**PATTON MARINE SURVEYORS
And CONSULTANTS, INC.**
P.O. Box 331884
Miami, FL 33233-1884, USA

December 14, 2024
File No.: 13717-24
Page 1 of 22

**RE: "SAPPHIRE", 2009,
50.44 Meter Trinity Motor Yacht**

RECOMMENDATIONS

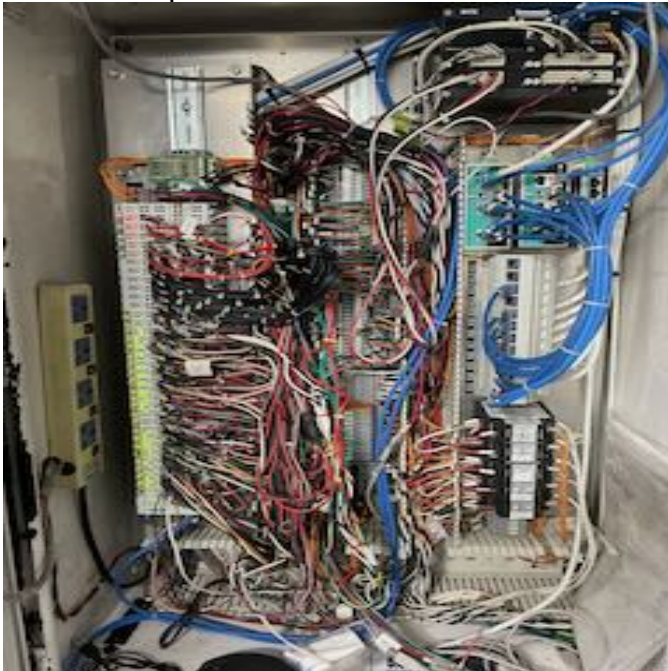
5. Supply cable to the fire pump has pulled from the motor connection housing. Re-install this motors supply cable. Multiple cable runs in the engine room, especially under the deck plates require additional cable support and protection.
